工程指示 / 要求簡箋 ENGINEER INSTRUCTIONS(E.I.)

工程指示編號:	EI- 4869C	修改版本:	C
	HK- 1528		
工程編號:	J 853	工程名稱:	大窩坪 (延坪道)
收件人:	生統	發件人:	Lai Sik Hung
工程項目:	T1及T7 幕牆單元背板生產 大貨 (修訂C:T1修改分格高度及避地台碼位)	日期:	05/09/2022

內容: 修訂C : T1修改分格高度及避地台碼位

名稱	轉角梗窗背板拆圖	制圖	陳敏聰	2022.04.13	修改	A	
材料	2mm鋁板	復核	謝永林	2022.04.14	日期	2022.09.02	
顏色	UCT542049SC-3(淺灰)	批准	Daniel		圖號	DBP-109

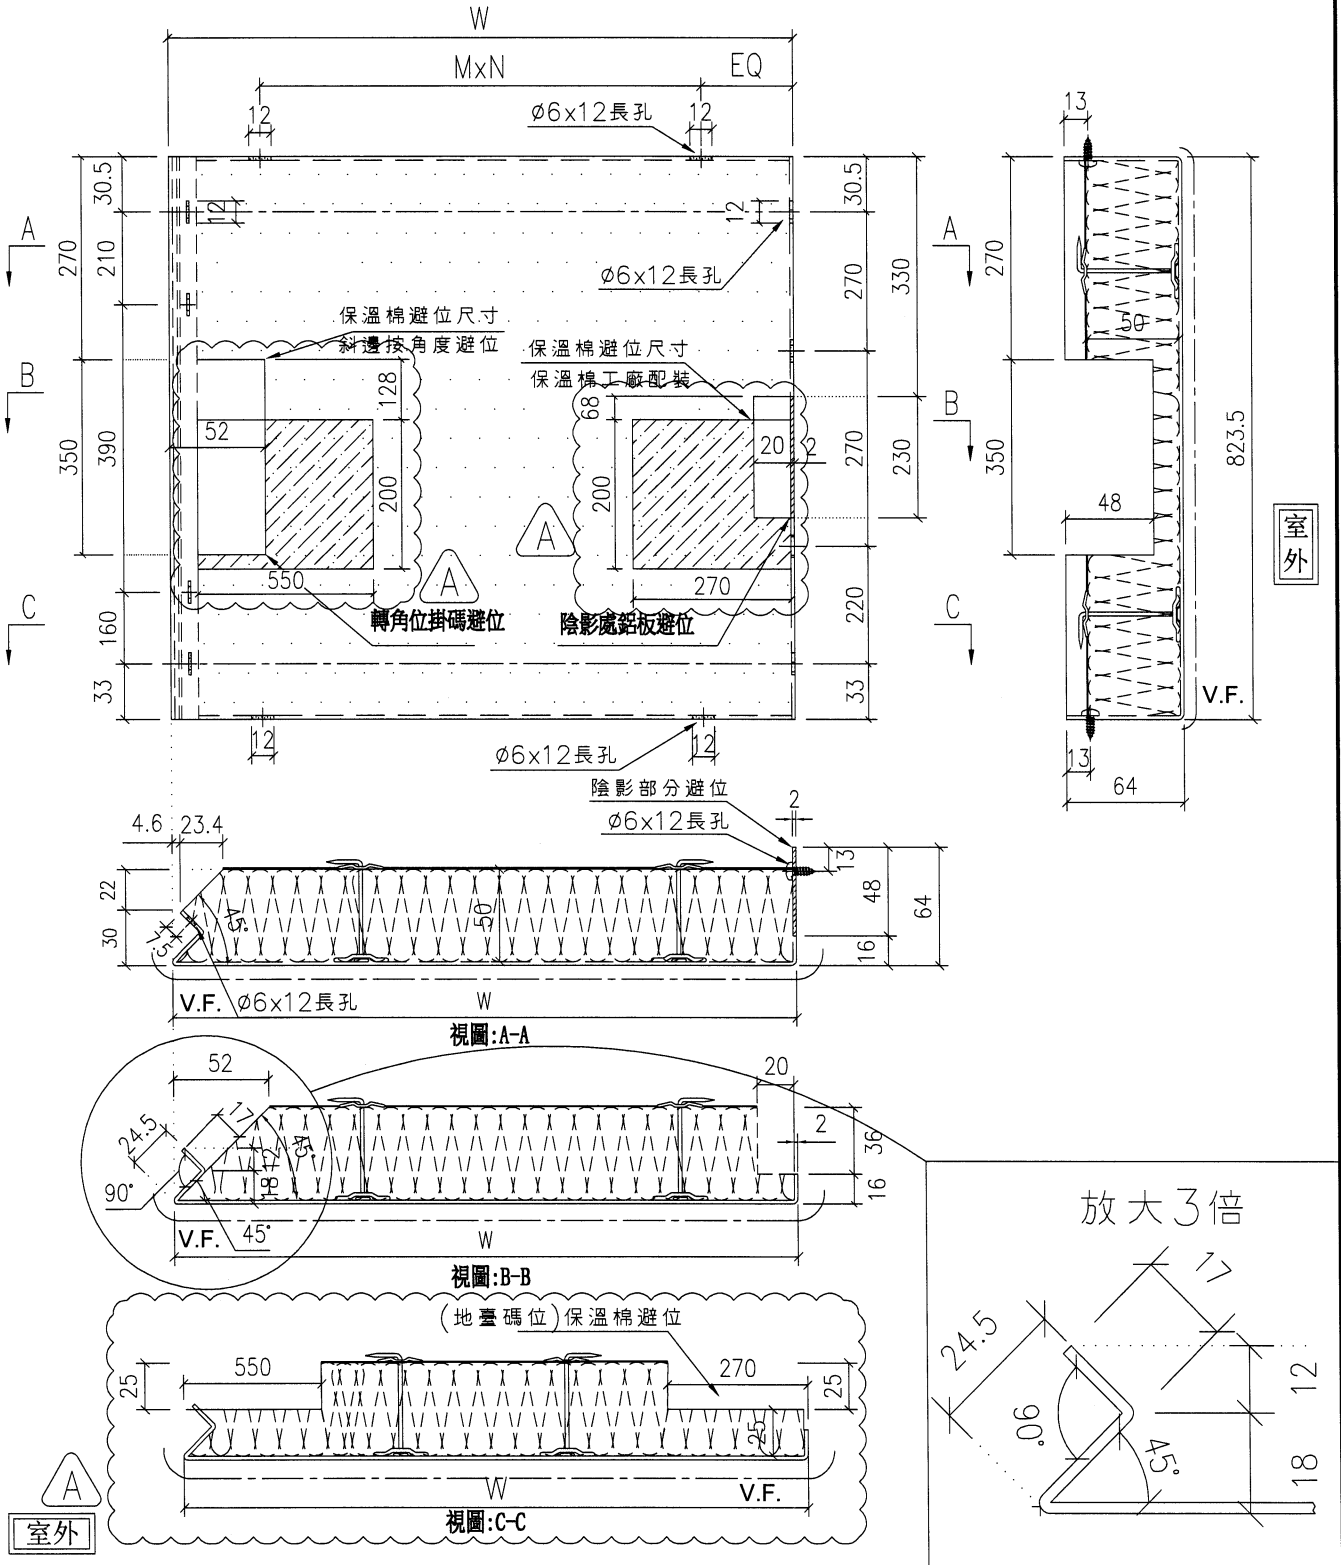
依據E14933避地臺碼位

名稱	轉角樑窗背板折圖	制圖	陳敏聰	2022.04.13	修改	A	
材料	2mm鋁板	復核	謝永林	2022.04.14	日期	2022.09.02	
顏色	UCT542049SC-3(淺灰)	批准	Daniel		圖號	DBP-111

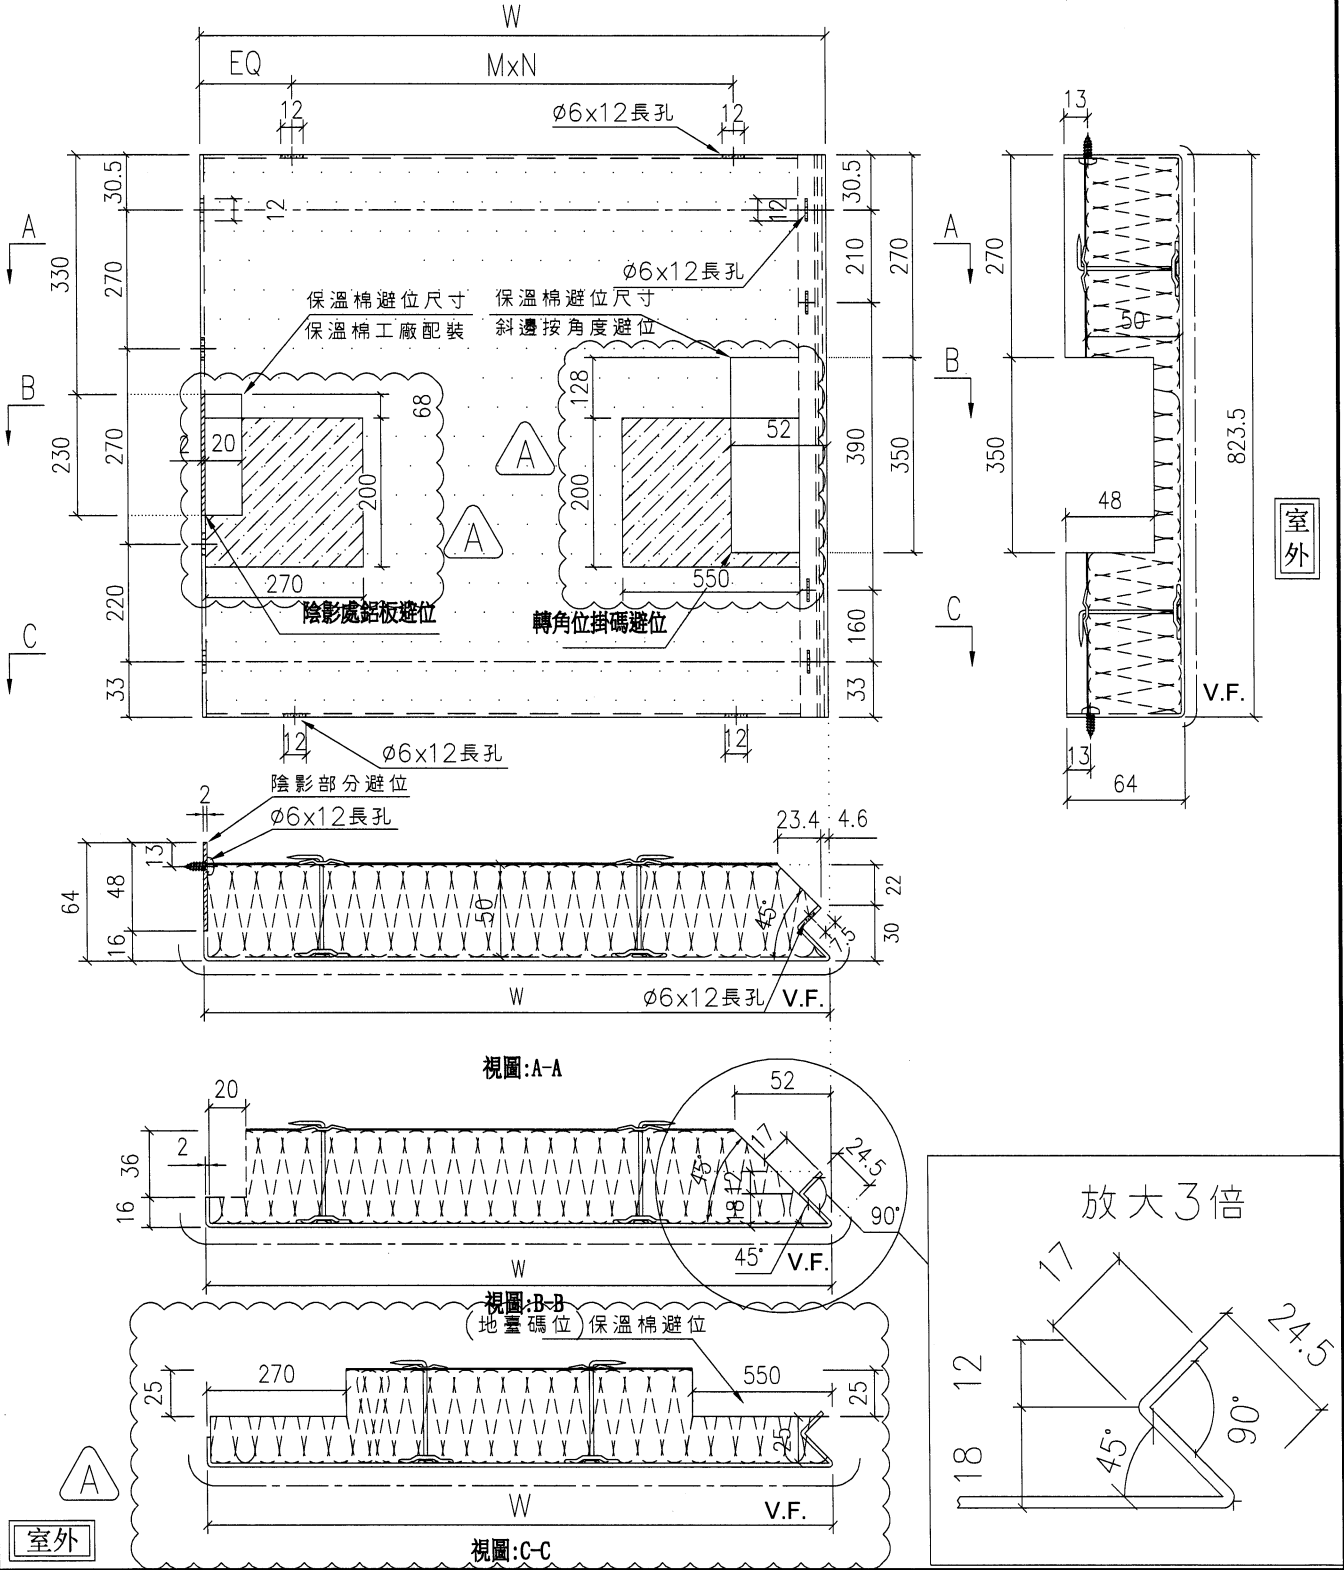
依據E14933避地臺碼位

名稱	轉角生窗背板拆圖	制圖	陳敏聰	2022.04.13	修改	A	
材料	2mm鋁板	復核	謝永林	2022.04.14	日期	2022.09.02	
顏色	UCT542049SC-3(淺灰)	批准	Daniel		圖號	DBP-41

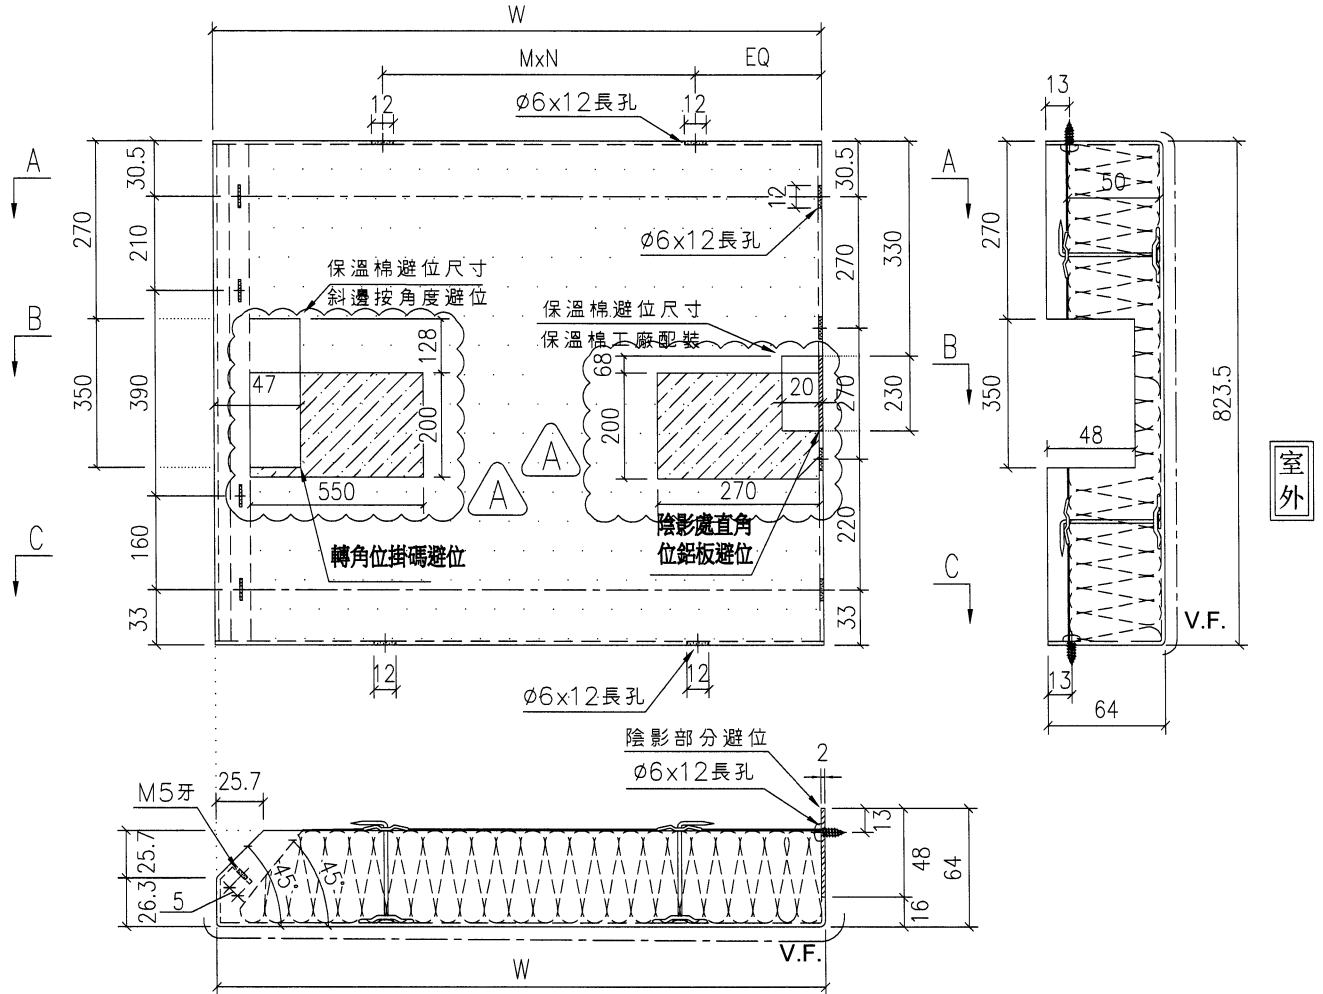
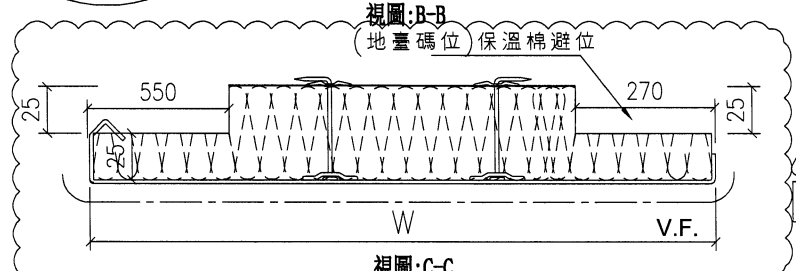
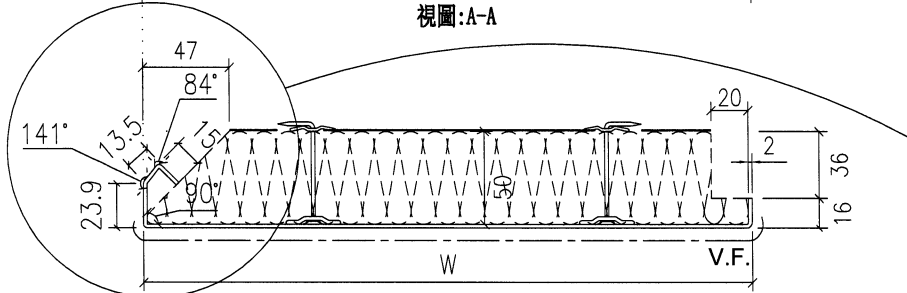
依據E14933避地臺碼位

名稱	轉角梗窗背板拆圖	制圖	陳敏聰	2022.04.13	修改	A	
材料	2mm鋁板	復核	謝永林	2022.04.14	日期	2022.09.02	
顏色	UCT542049SC-3(淺灰)	批准	Daniel		圖號	DBP-109k

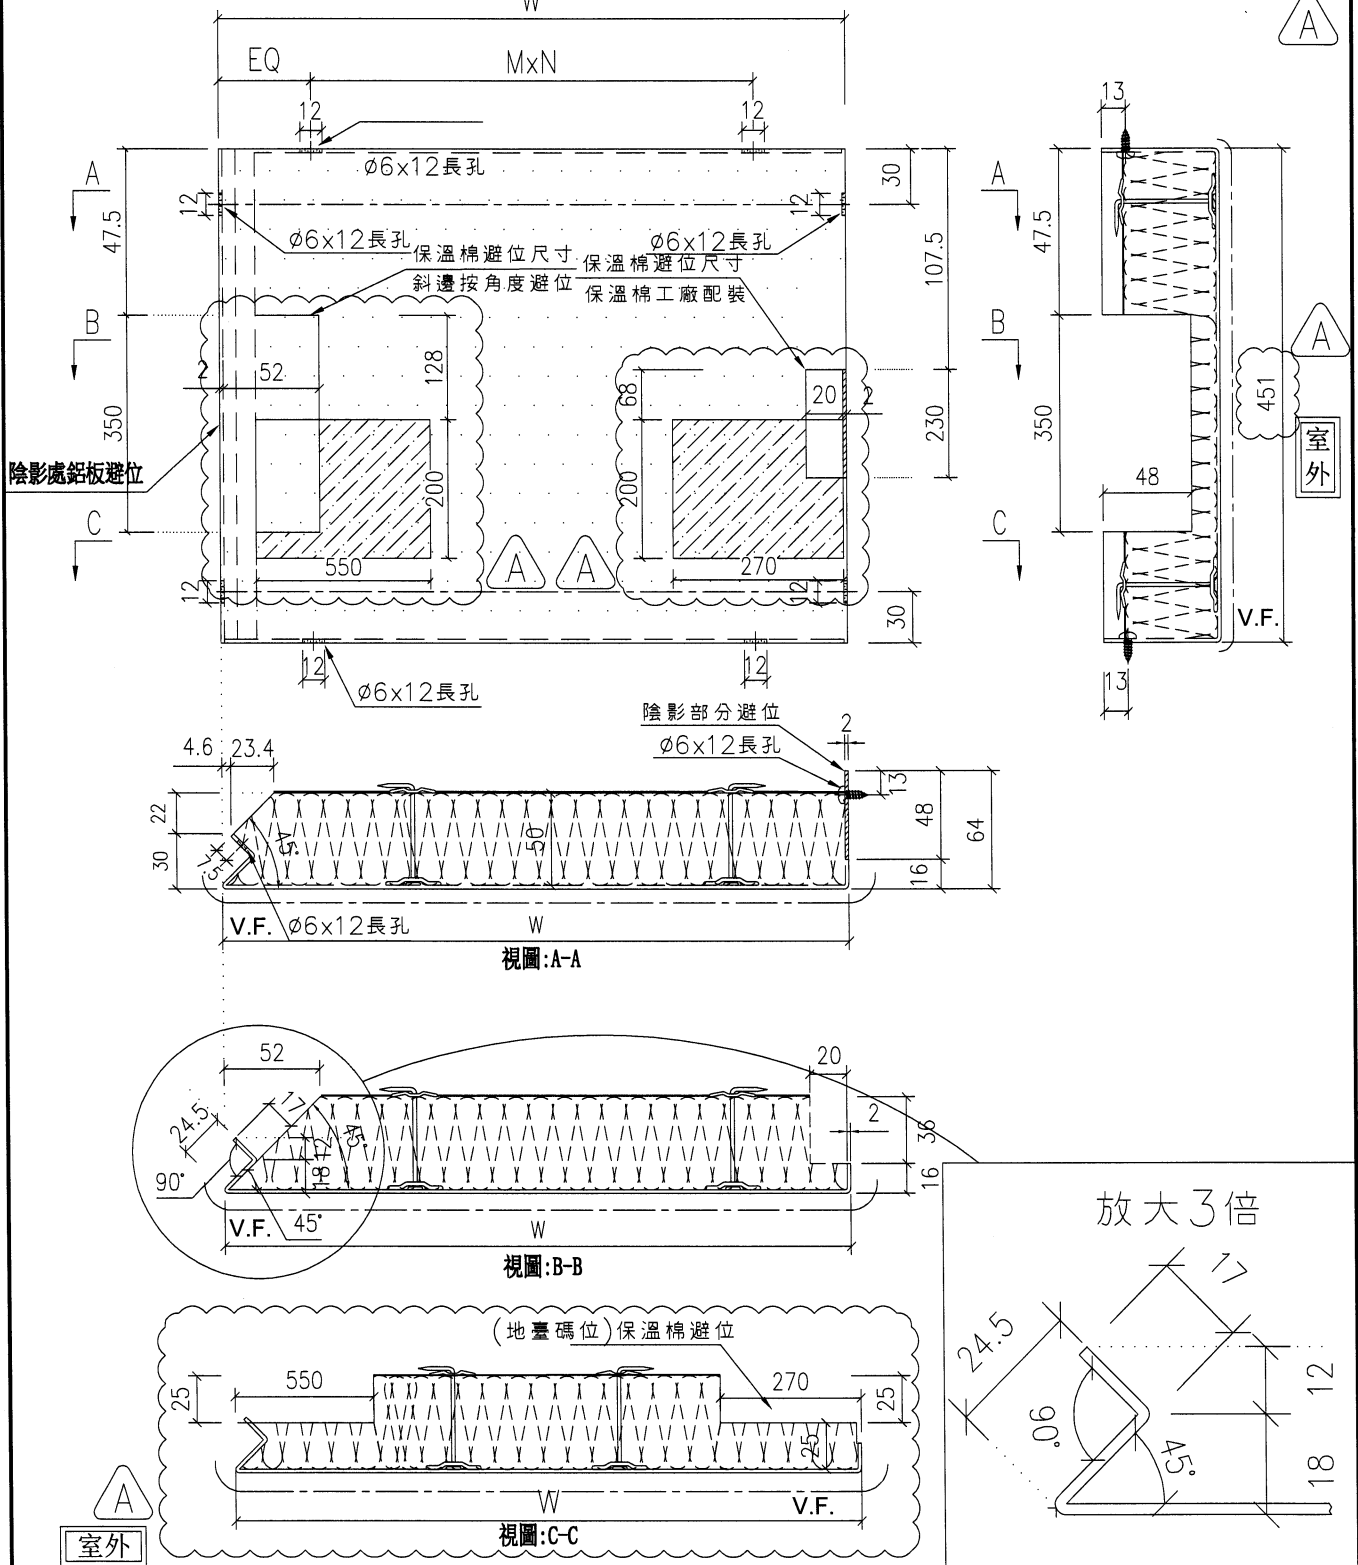
依據E14933避地臺碼位

依據E14949修改分格高度

物料編號	W	數量	EQ	M	X	N	位置	分格尺寸	樓層	樓層數	每層數量	備註
DBP-109k	1510.5	1	130.3	250	x	5	J853-SD-CW-4103	1725	22/F	1	1	原340改585

名稱	轉角梗窗背板拆圖	制圖	陳敏聰	2022.04.13	修改	A	
材料	2mm鋁板	復核	謝永林	2022.04.14	日期	2022.09.02	
顏色	UCT542049SC-3(淺灰)	批准	Daniel		圖號	DBP-111a

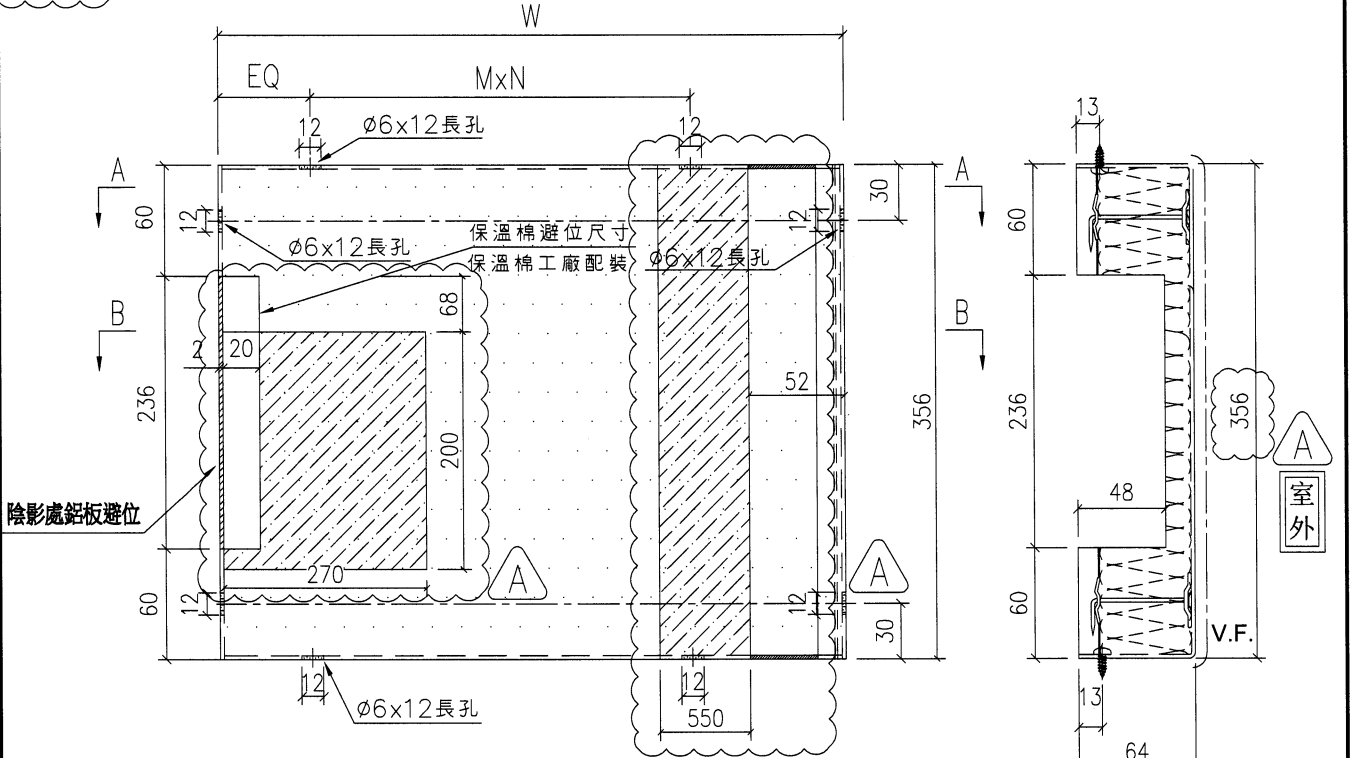
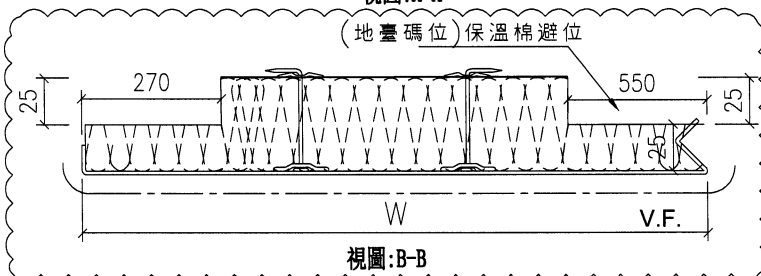
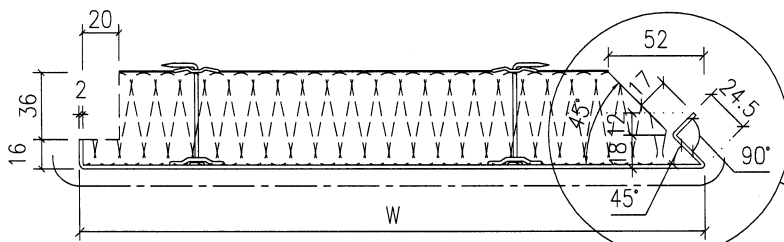
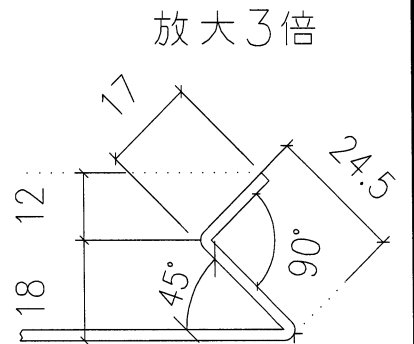
依據E14933避地臺碼位

依據E14949修改分格高度

物料編號	W	數量	EQ	M	X	N	位置	分格尺寸	樓層	樓層數	每層數量	備註
DBP-111a	1685.5	1	92.8	300	x	5	J853-SD-CW-4103	1900	25/F	1	1	原340改490

?待定, ¹/₆₀₀₇ 節點與立面掛碼位不符, 香港確定

名稱	轉角生窗背板拆圖	制圖	陳敏聰	2022.04.13	修改	A	
材料	2mm鋁板	復核	謝永林	2022.04.14	日期	2022.09.02	
顏色	UCT542049SC-3(淺灰)	批准	Daniel		圖號	DBP-41a

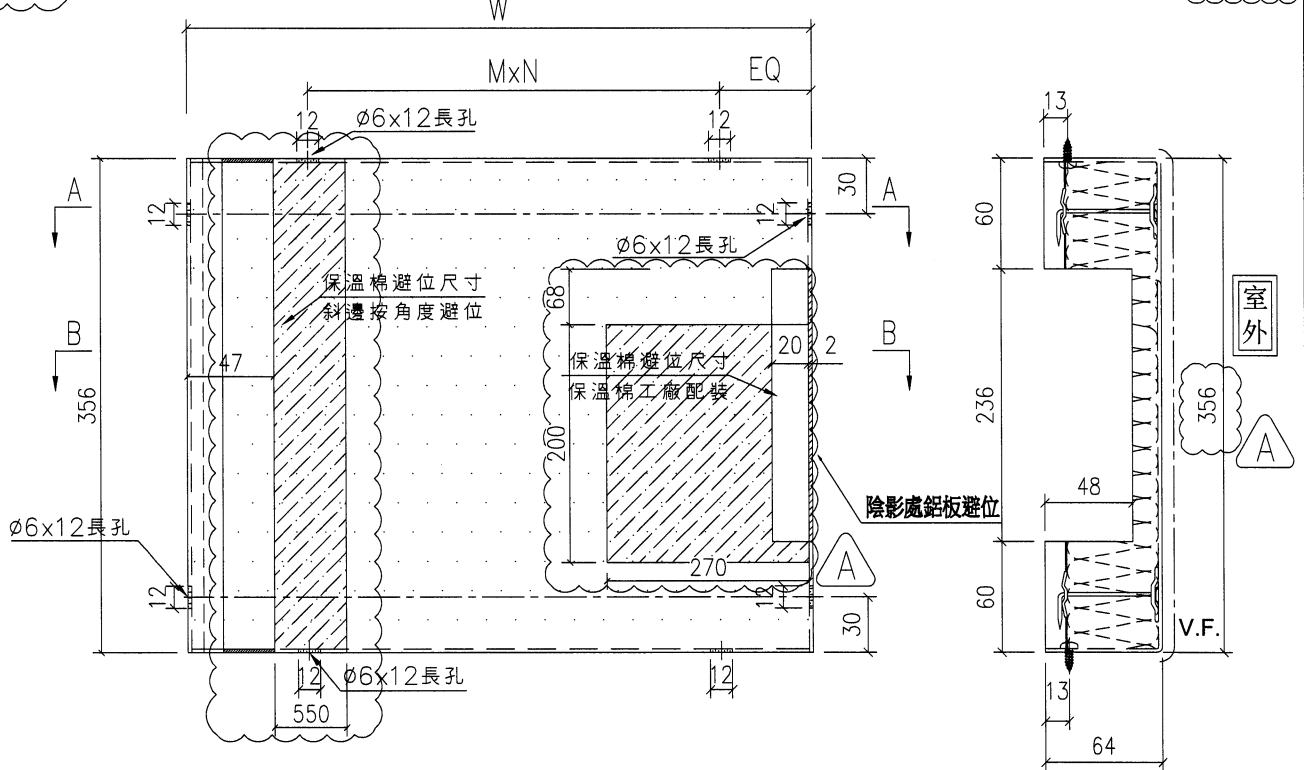
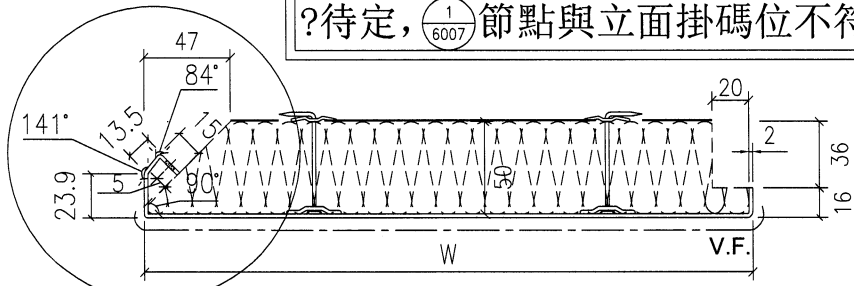
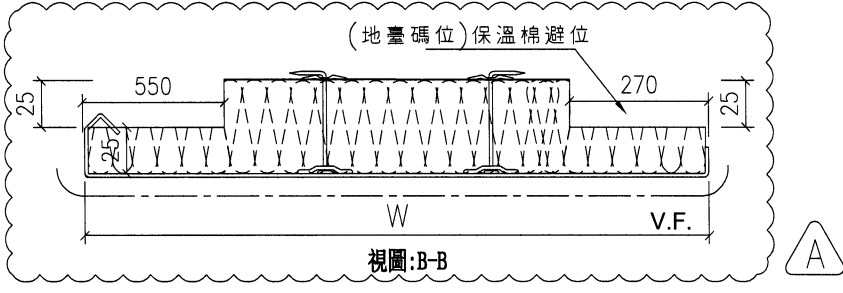
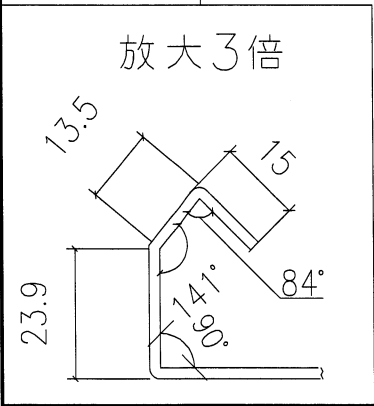
依據E14933避地臺碼位

依據E14949修改分格高度

物料編號	W	數量	EQ	M	X	N	位置	分格尺寸	樓層	樓層數	每層數量	備註
DBP-41a	882	1	66.0	250	x	3	J853-SD-CW-4103	1100	25/F	1	1	原340改490

?待定, $\frac{1}{6007}$ 節點與立面掛碼位不符, 香港確定
